May 18, 2021

COMPREHENSIVE FEEDBACK

The following schematic of a potential stepped-shape building was provided:

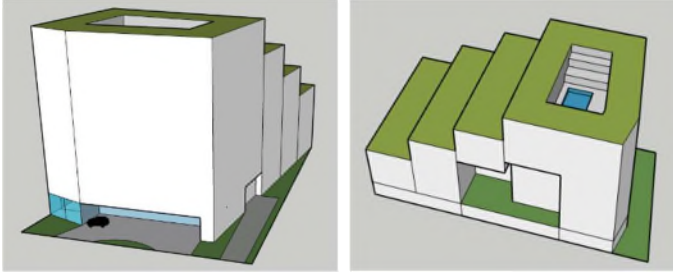
- Stepped shaped building. **A stepped shaped building will not work at this location due to the size constraints of the site.**
- It is so ugly, a cross between an ice tray and a lego brick. If it has to be there can't it be beautiful?
